Errata Sheet

Product Family:	DL305	Date:	12.04.2023
Manual Number	D3-USER-M		
Revision and Date	1st Edition, Rev. D; January 2010

Page 2-12. Base Wiring

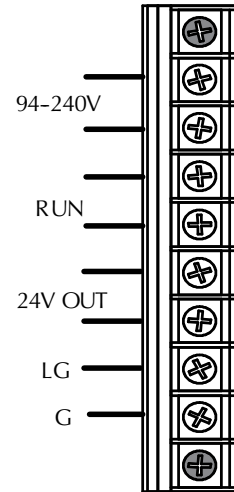
On newer 110-240 VAC bases, the terminal strip has been re-designed and does not have different terminals for 110VAC and 240VAC connections. If you have one of these re-designed bases the terminal strip will look like the graphic shown here.

Page 3-9. DL330/DL330P CPU Setup; Installing the UVPROM Option in the DL330/DL330P CPU.

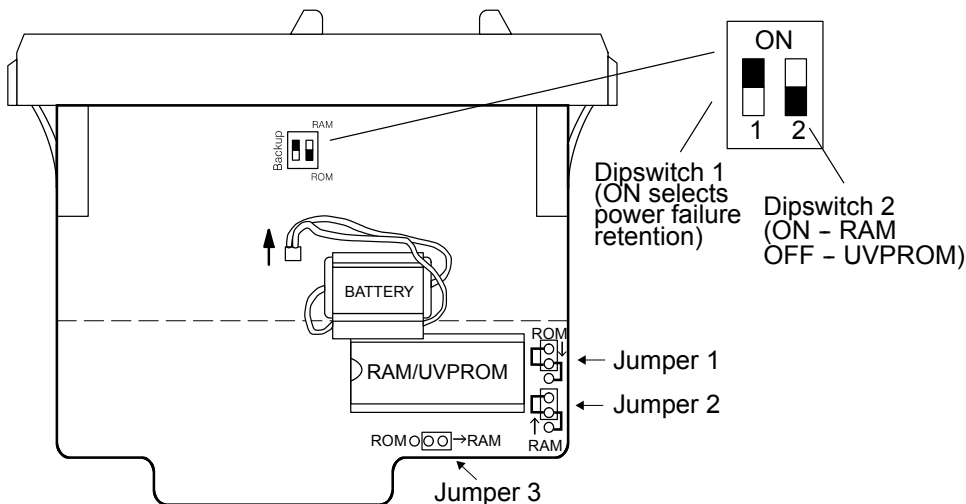
The drawing showing the jumpers is missing the silkscreen jumper lines and arrows for jumpers 1, 2, and 3. Refer to this drawing.

Reset the PLC to Factory Defaults

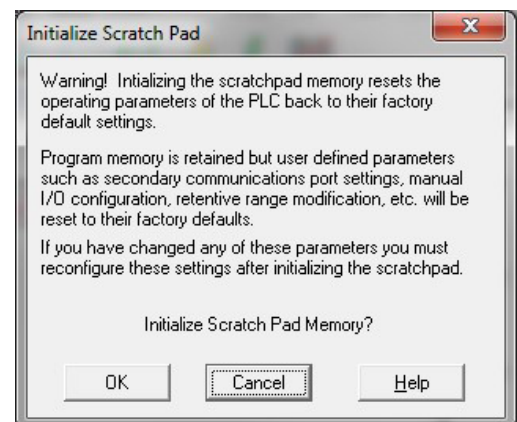
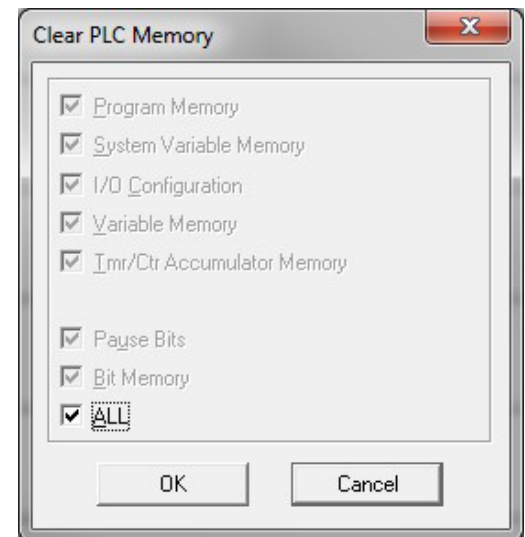
Step 1 – While connected to the PLC with DirectSoft, go to the PLC menu and select; "Clear PLC Memory". Check the "ALL" box at the bottom of the list and press "OK".

Step 2 – While connected with DirectSoft, go the PLC menu and then to the "Setup" submenu and select "Initialize Scratch Pad". Press "Ok".
